TOWN OF BROOKLYN PLANNING AND ZONING COMMISSION PUBLIC HEARING LEGAL NOTICE

Re: Wetland function/value and impact assessment report for proposed parking expansion for Vachon Chevrolet, Providence Road, Brooklyn, Connecticut.

ENGINEERING PLAN REVIEW
PERTAINING TO
PROPOSED PARKING EXPANSION
VACHON CHEVROLET
(Assessor's Map 41, Lots 13A & 14)
PROVIDENCE ROAD (ROUTE 6)
BROOKLYN, CT

In response to NECCOG review comment on the aforementioned project, we offer the following:

SITE DEVELOPMENT PLAN No. 1

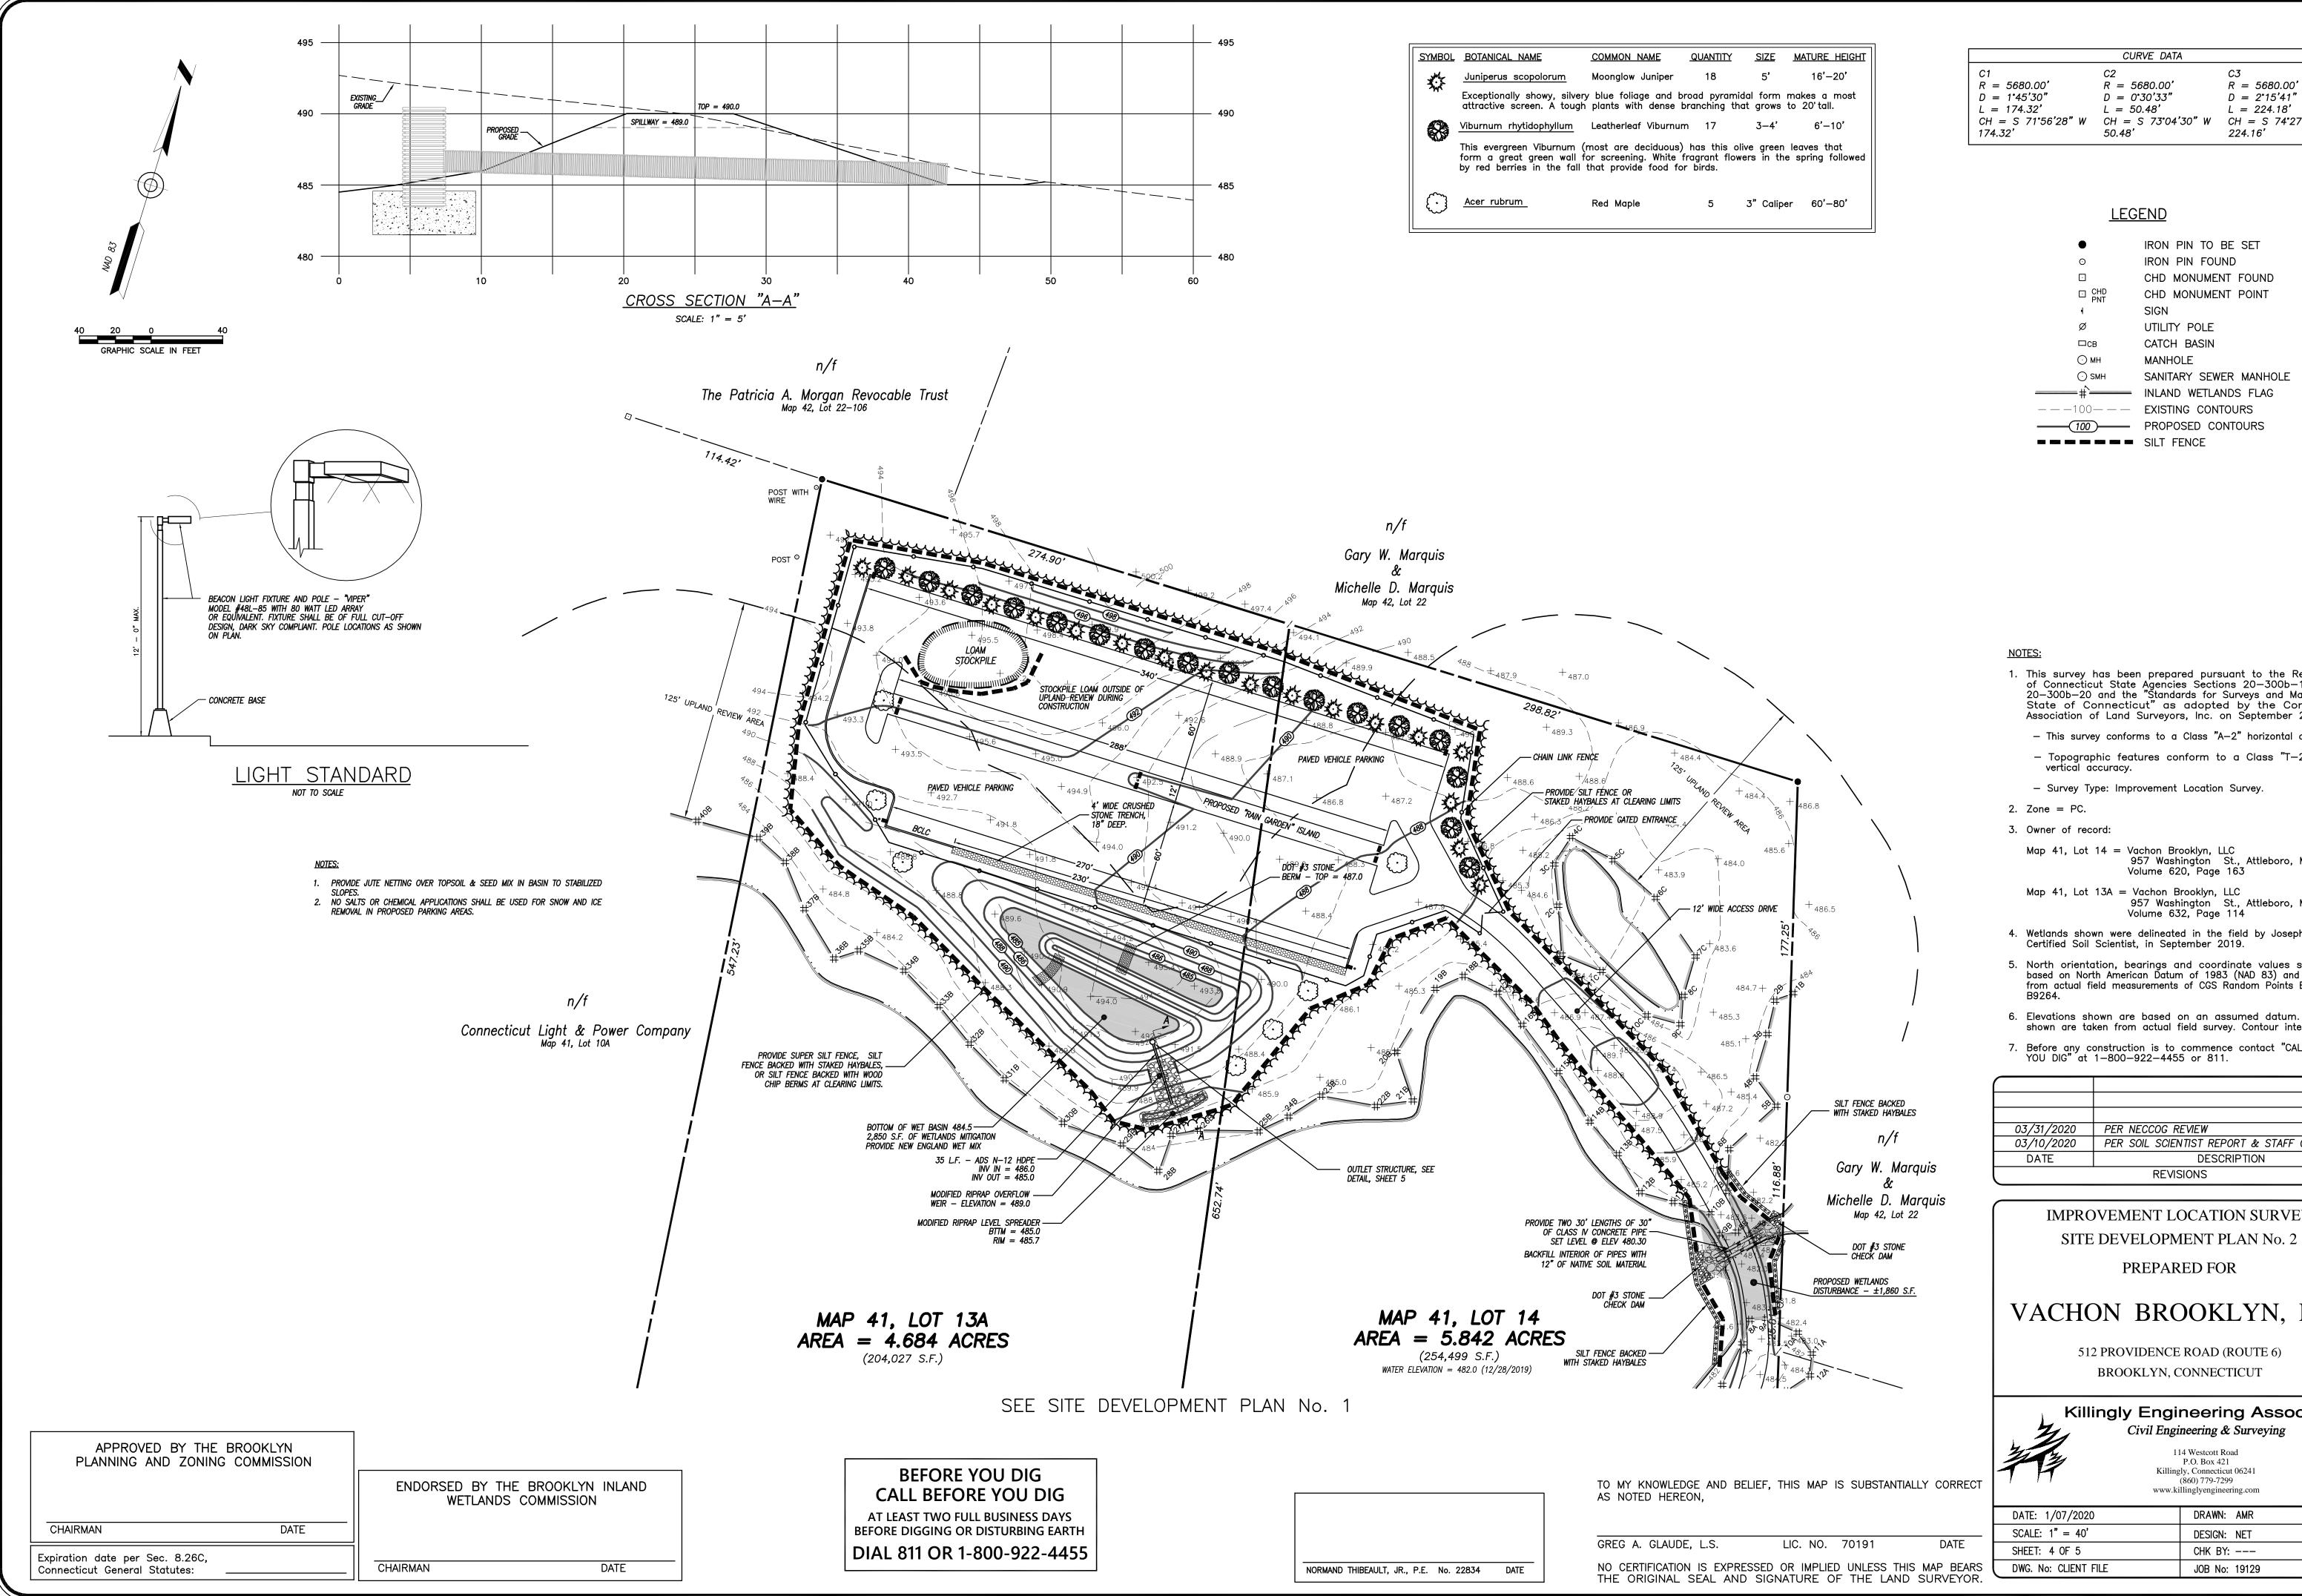
- A construction entrance symbol is drawn at the entrance to the new "paved vehicle storage area."
 However, a note should be included to indicate that this will be removed at the time the first course
 of paving is installed for the vehicle storage area. Additionally, it would be helpful for this
 explanation to be included in Note 17 under "Development Schedule/Sequence of Operations" that
 appears on Sheet 5 of 5 of the plan set.
- 2. The note "Silt Fence Backed with Staked Haybales or Wood Chip Berms" should read the same as the note on Sheet 4 of 5, "Provide Super Silt Fence, Silt Fence Backed with Staked Haybales, or Silt Fence Backed with Wood Chip Berms at Clearing Limits." for consistency.

- 1. A note has been added to the plan to direct the contractor to remove the anti-tracking construction entrance prior to installing the first course of payement. This has also been noted on sheet 5 of 5 in the development schedule/sequence of operations.
- 2. The note "silt fence backed with staked haybales or wood chip berms" has been modified to read the same on all sheets.

DETAIL SHEET

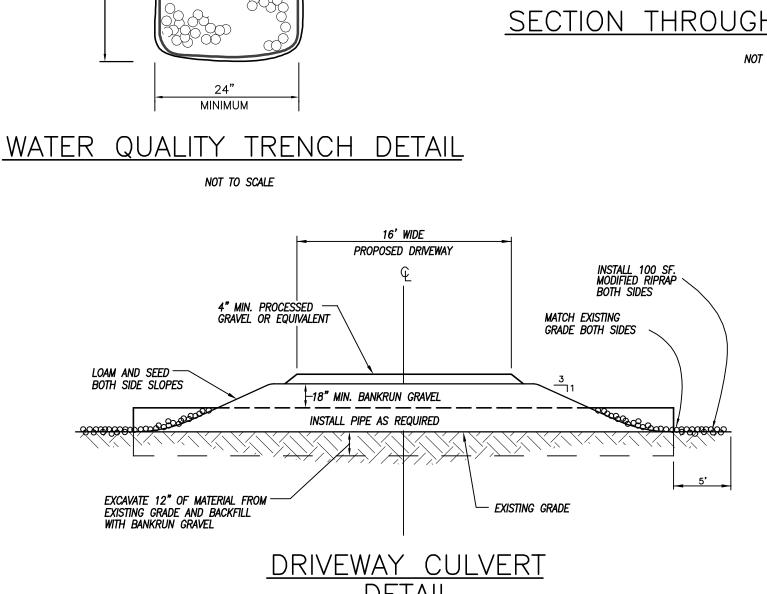
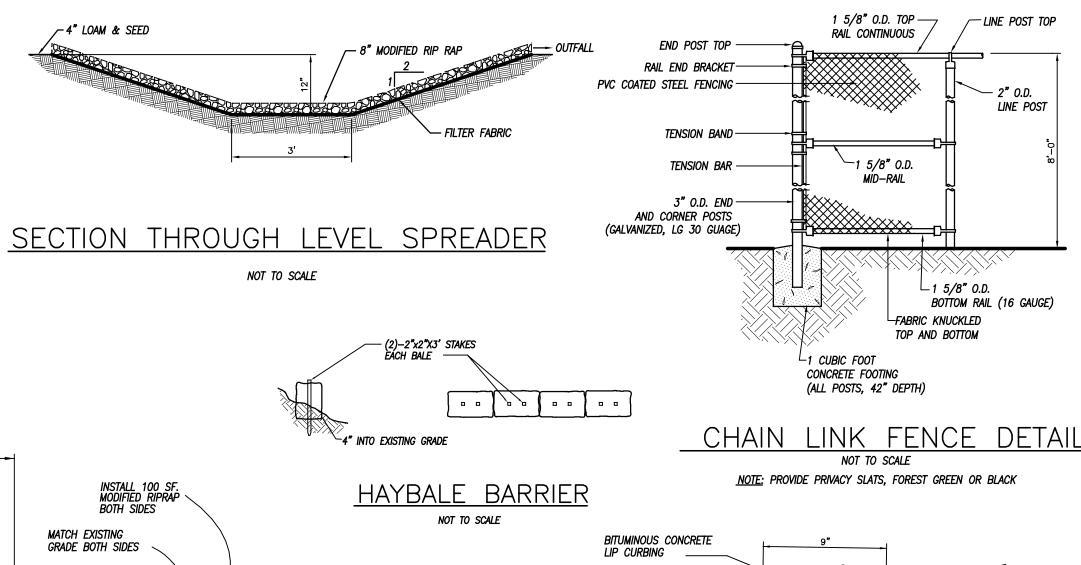
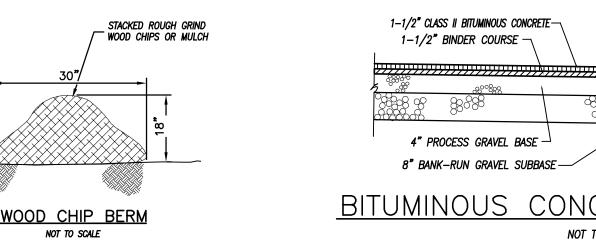
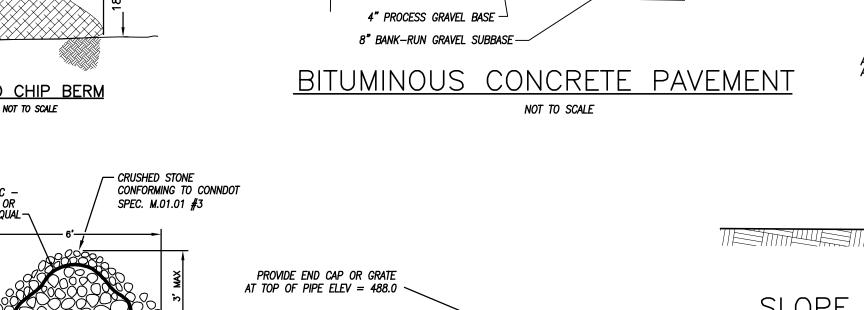
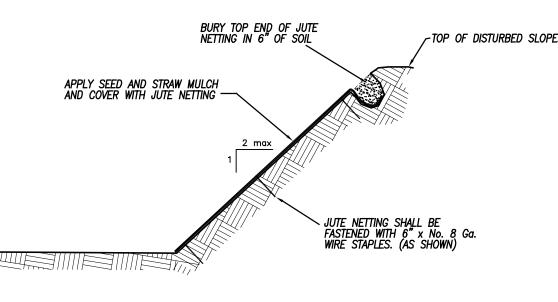
- In the "Stormwater Basin Outlet Detail," a smooth outer wall PVC pipe may be less susceptible to upheaval or degradation (breakage) by icing conditions than a corrugated type of pipe. It is recommended that this be evaluated by the designer. Furthermore, over time, ultraviolet rays in sunlight degrades unprotected plastic pipe, which causes it to lose structural integrity and stability. Considering this, concrete may be a better choice.

- 2. In the "Stone Berm" detail, what specific type of filter fabric should be used to minimize sediment transport and at the same time allow the efficient transmission of water toward the outlet structure? This should be specified in the detail. Also, what are the conditions as to when the berm should be replaced to function as designed due to sediment build up?

- 3. It is recommended that the "Silt Fence Backed with Haybales" detail title be modified to read "Super Silt Fence (Silt Fence Backed with Haybales or Wood Chip Berms)."

- 4. In the "Chain Link Fence Detail" the gauge of the fence fabric and size of the selvage should be specified and also what type of material it is manufactured from (galvanized steel, PVC coated steel, etc.). The same goes for the posts and hardware, too, and depth of bury/concrete anchorage for the posts.

- 5. In the "Stone Berm" detail, will CONNDOT crushed stone M.01.01 #3 remain stable at a 2:1 angle of repose?
- 6. In the "Slope Stabilization Detail" it is recommended that the slope be 3:1 or flatter, NOT 2:1 or steeper, as shown.

- 7. In the "Bituminous Lip Curb" detail it is recommended that the curb be formed on the binder course (locked in) for better stability/longevity, which should provide more resistance to deformation by snowplowing operations or other vehicle impacts.

- 2. For the stone berm, specifications for the filter fabric have been called out and conditions for maintenance are defined.
- 3. The silt fence detail has been modified to read "super silt fence" as requested.

- 4. The detail for the fence installation has been modified as requested. In addition, neighbors who attended the public hearing for wetlands requested an 8' fence in lieu of a 6' fence which has been accommodated.

- 6. We have modified the slope stabilization detail to call for application on slopes 2:1 or flatter per 5-4-10 of the 2002 Guidelines.
- 7. Bituminous curb installation detail has been modified accordingly as requested.
